Project:	Vine Street, Gorton	Job No:	3763
Subject:	Drainage Technical Note		
Prepared by:	A Matadar	Date:	18/03/2025
Approved by:	E Dale-Maude	Date:	18/03/2025

- 1.1 This Technical Note has been prepared to support a discharge of conditions application relating to planning application ref: 137751/MO/2023, for a proposed development at Vine Street, Gorton.
- 1.2 A discharge of conditions application has previously been submitted to Manchester City Council and comments have been received from the LLFA requesting further information. The table below aims to address the outstanding concerns raised and provide further information relating to condition 19 (drainage)

TITLE:
HYDROBRAKE
GA

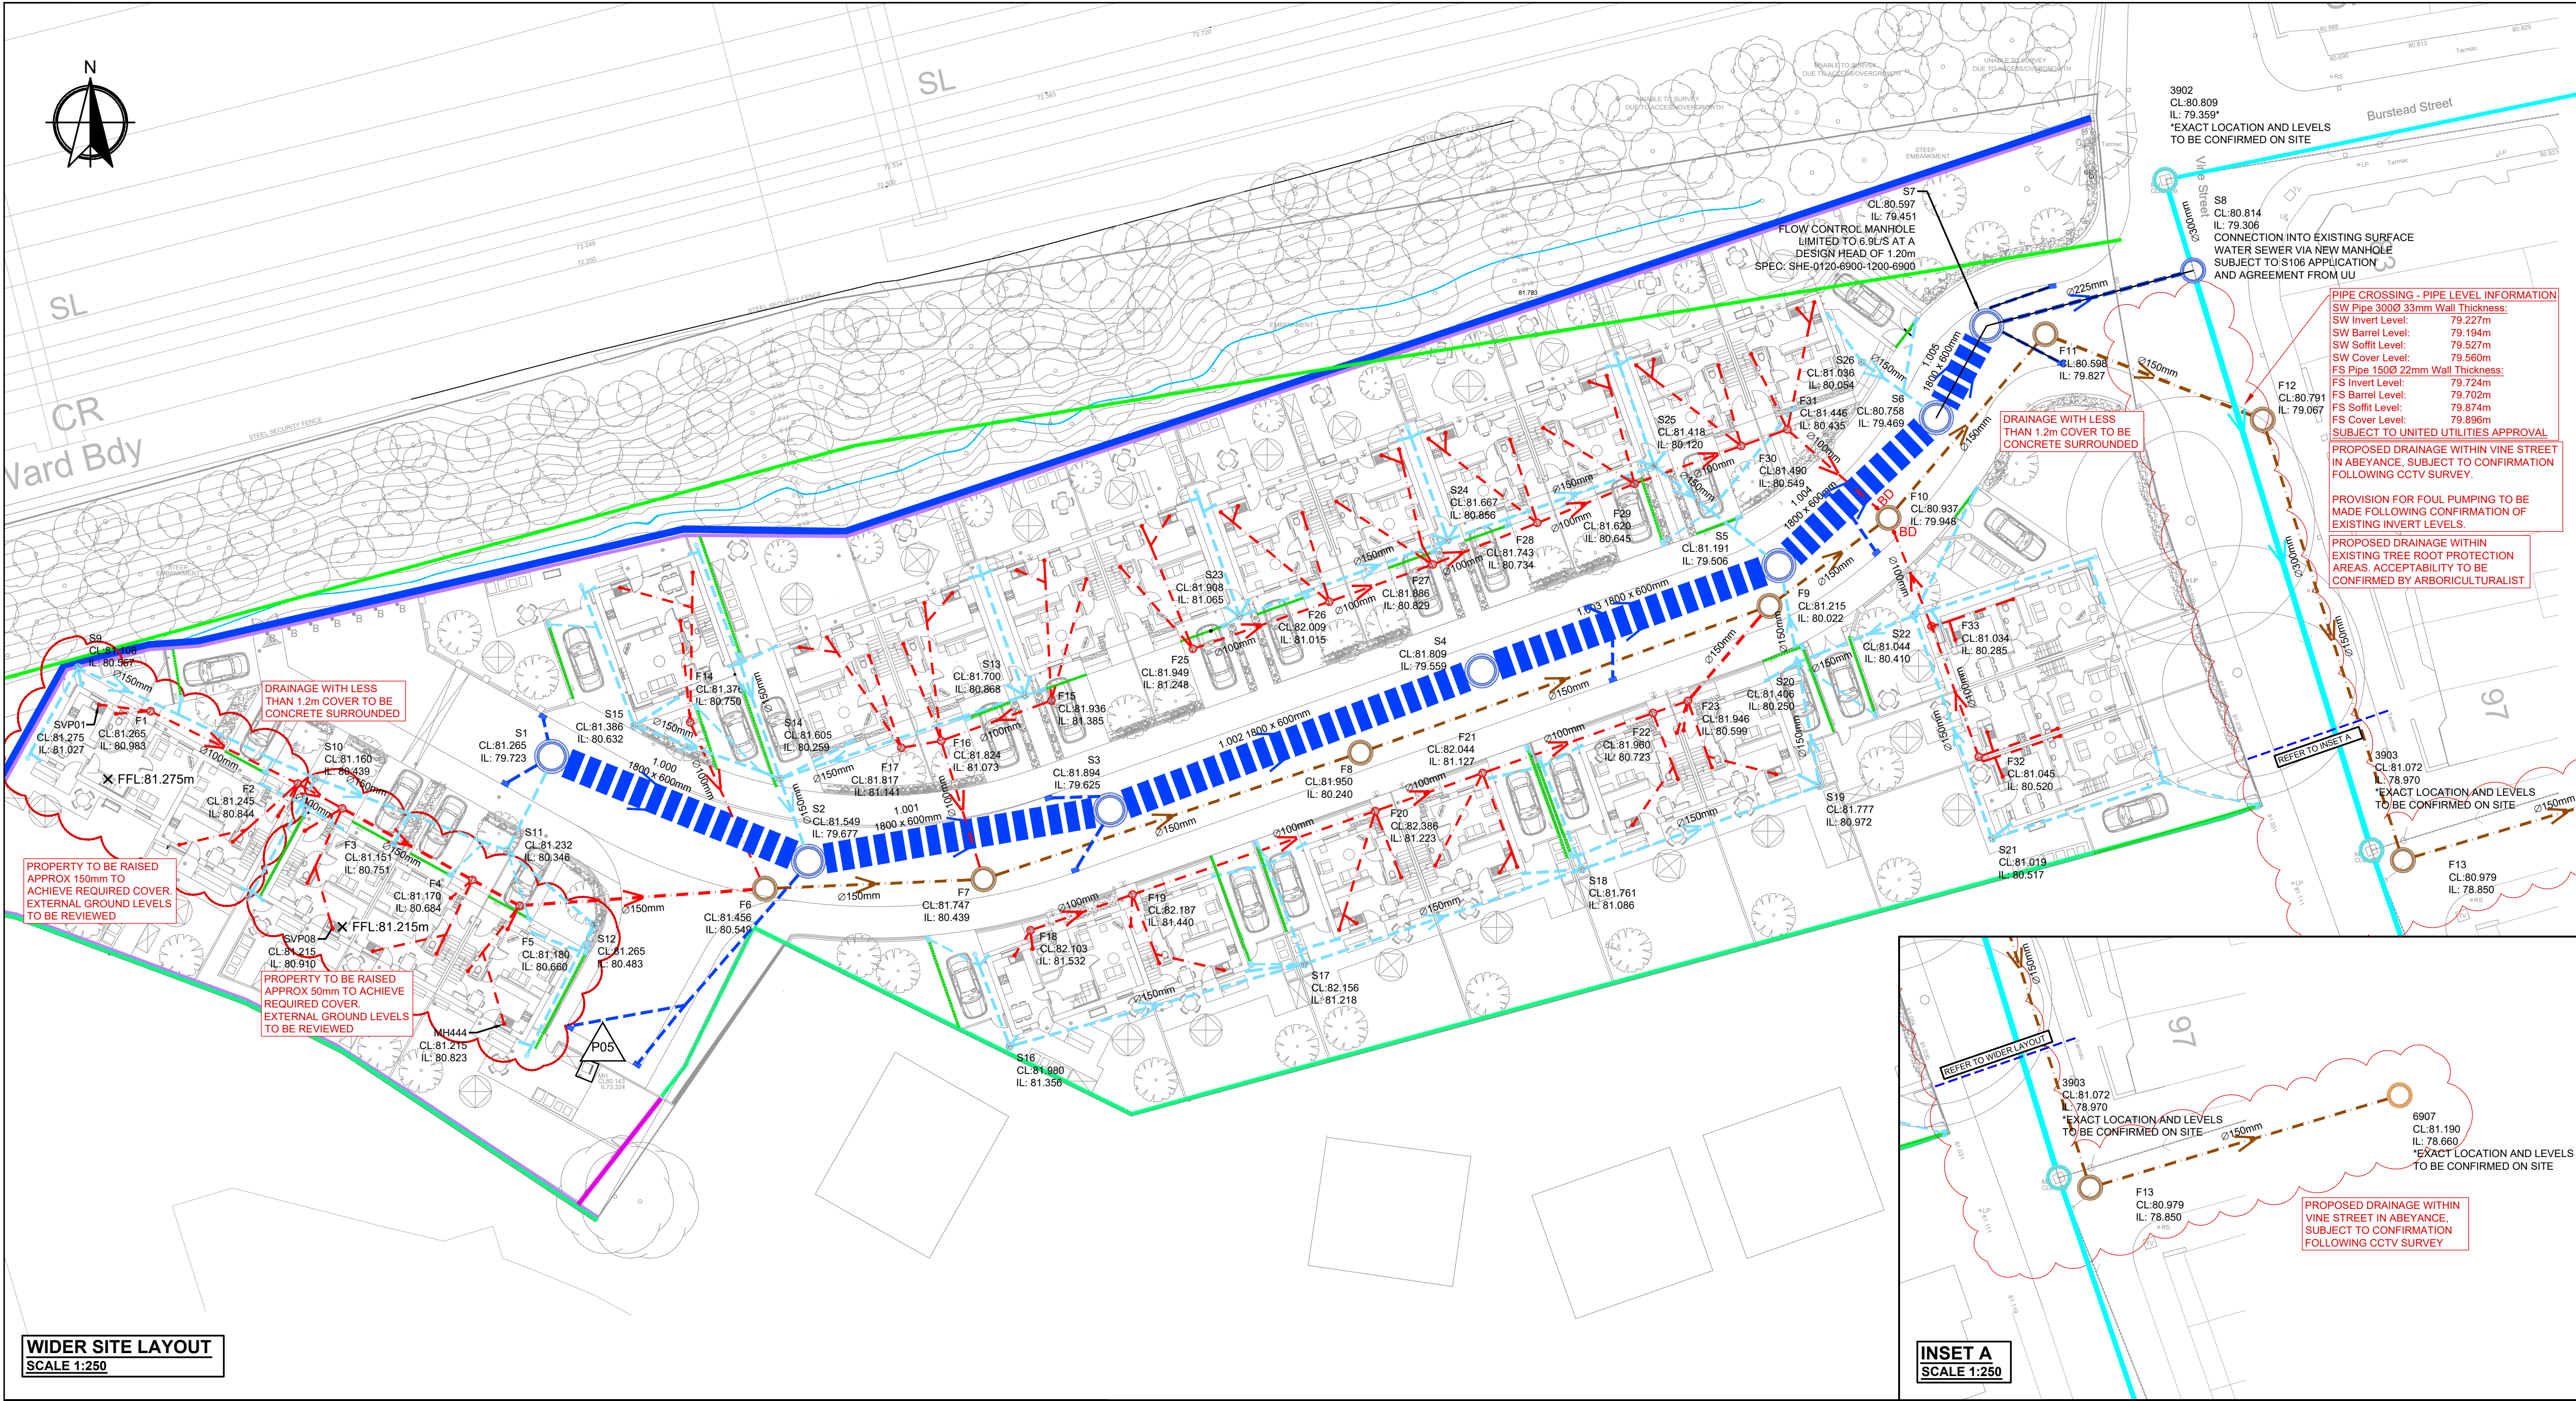
Section details of proposed hydro-brake must indicate top water level for 1:1, 1:30, 1:100 + 40% climate change. To deem if the structure is acceptable and / or provide safeguarding measure, due to 'overflow pipework'.	A flow control detail has been provided within Appendix 1. Water levels for the various storm events has been noted on the flow control section detail.

TITLE:
PROPOSED EXTERNAL WORKS LAYOUT

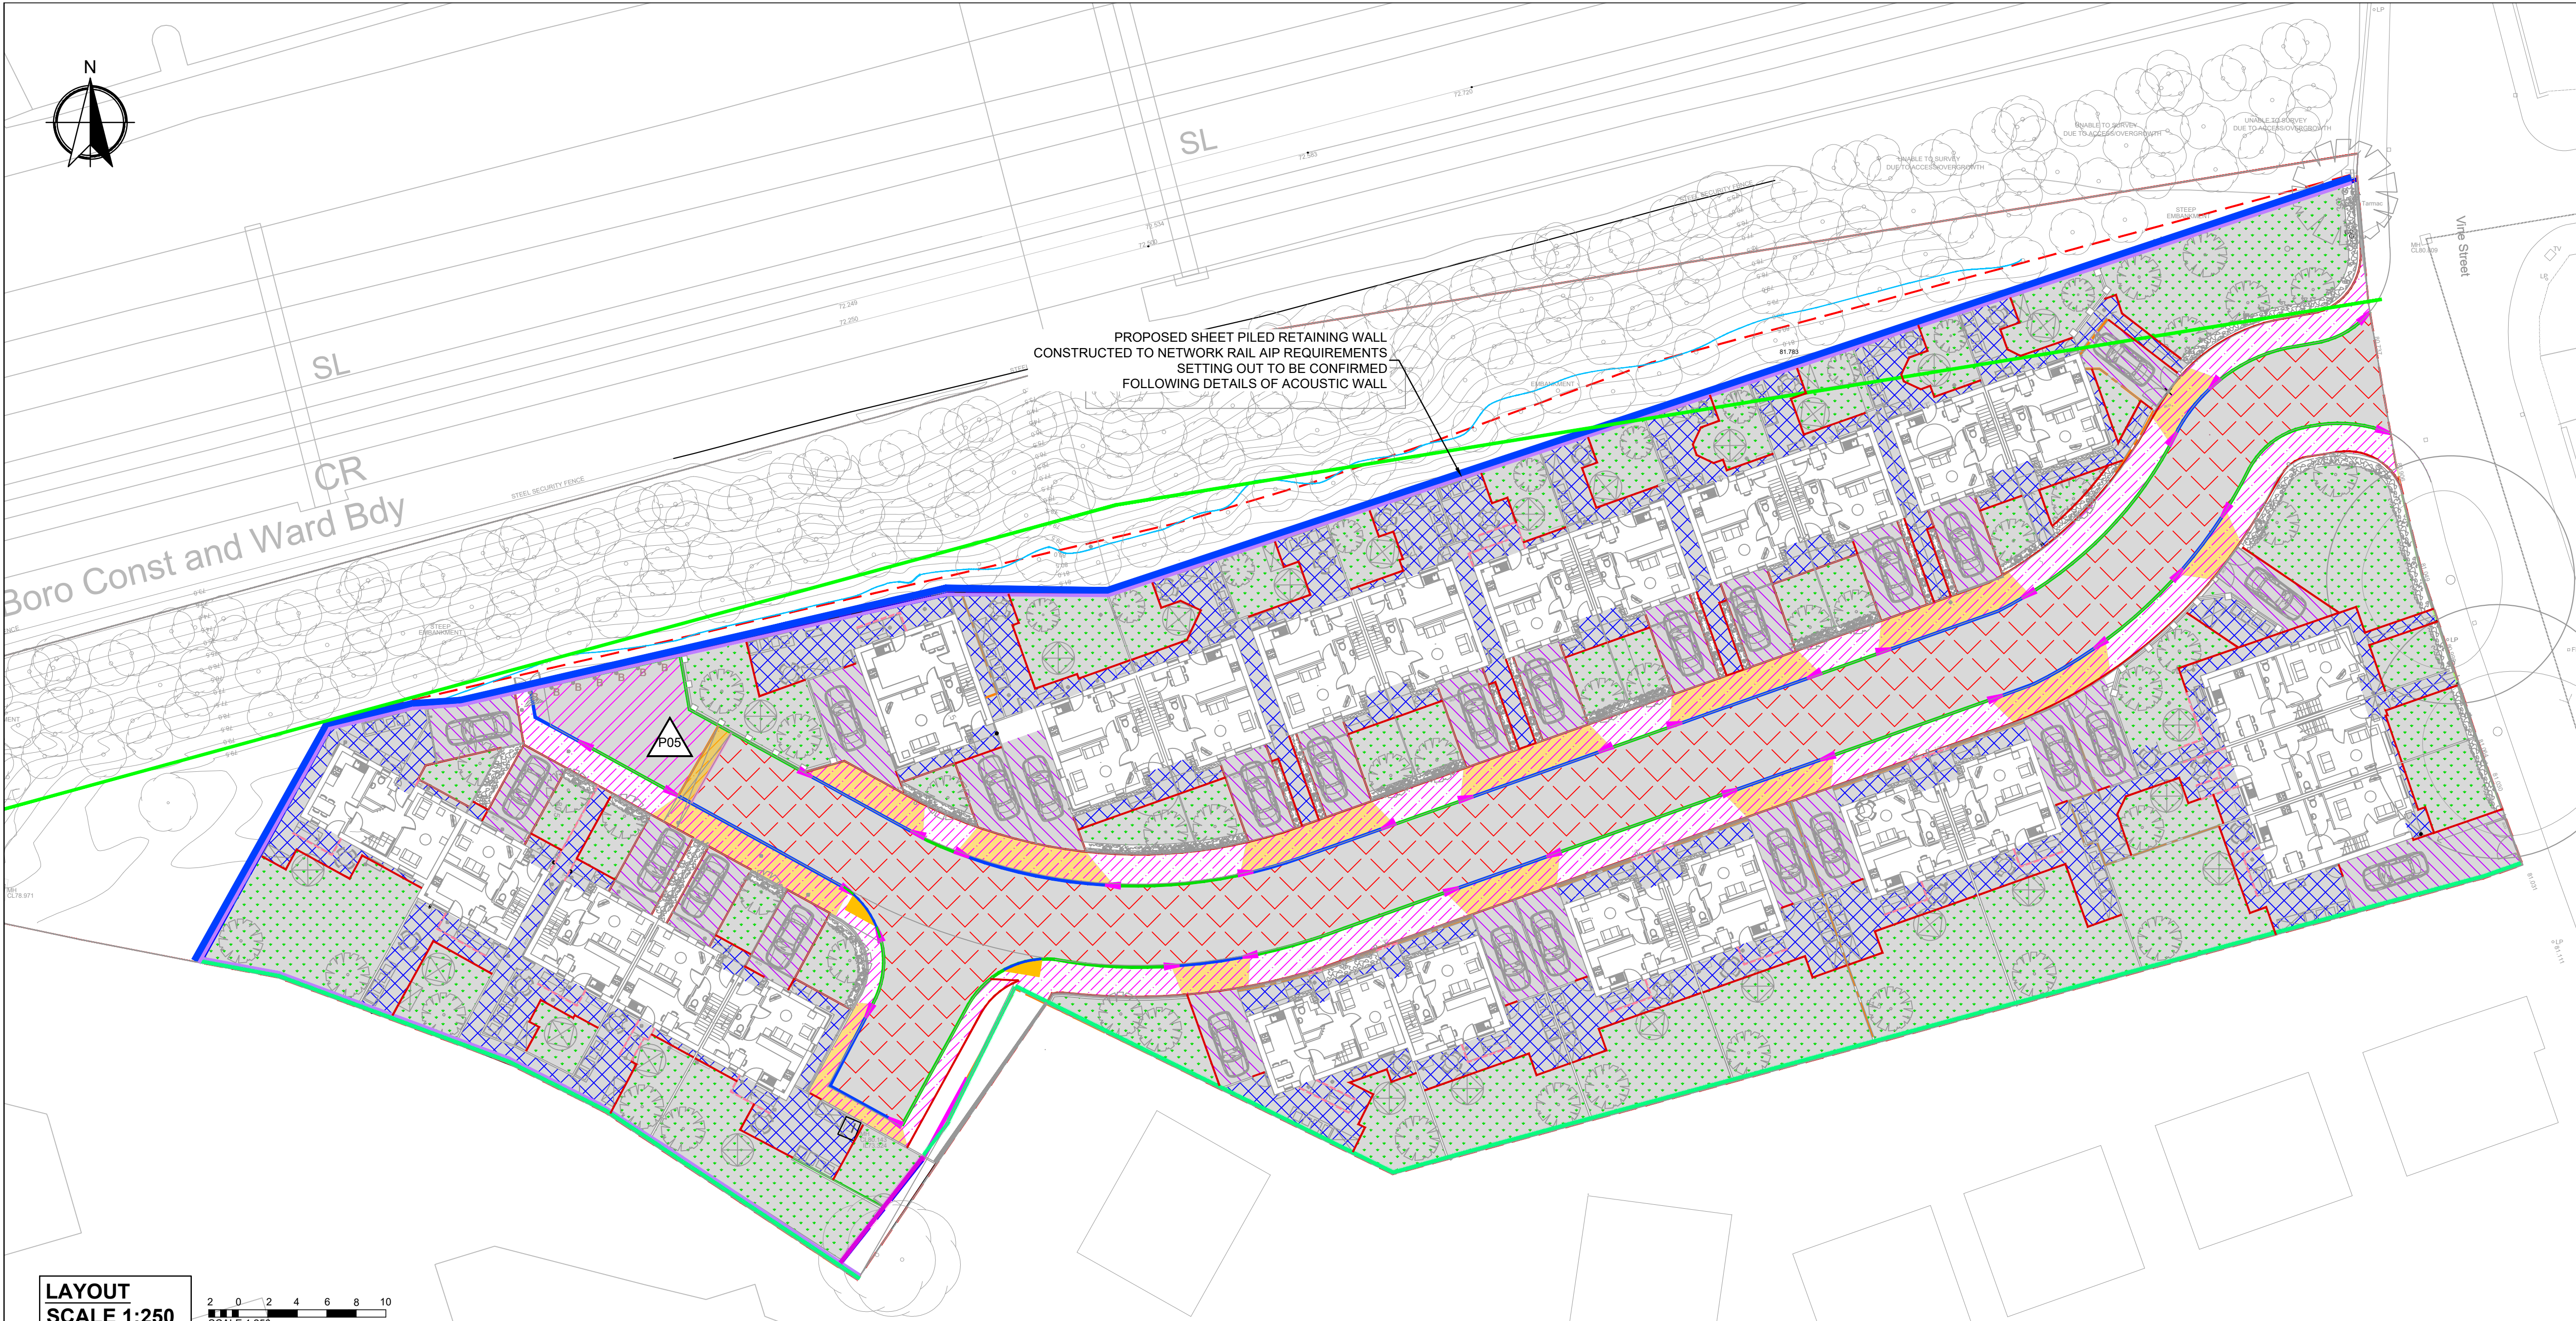
Decision Notice Clause	Ridge Response
Notwithstanding the historic site investigation (report AG3211-20-AL43 by Applied Geology), the strategy should demonstrate maximised integration of green SuDS components to retain the baseline drainage characteristics of the greenfield site.	The baseline greenfield runoff rate is retained for the post development scenario with flow restrictions mimicking the greenfield flow. Given the scale and type of development, there are limited spaces for green SuDS incorporation. The only 'green' areas of the site post development are the private gardens which are at a standard size. These gardens will continue to drain as per the existing greenfield site, and the planting strategy proposed as part of the soft landscaping scheme will provide wider amenity and biodiversity benefits. Permeable paving has been incorporated on all driveways.
Evidence that front driveway surfacing >5m2 is designed with permeable materials (such as permeable paving or permeable asphalt) in line with Government Guidance.	Please refer to drawing VSG-RDG-XX-XX-DR-C-0009 – External Works Layout in Appendix 1 for confirmation.
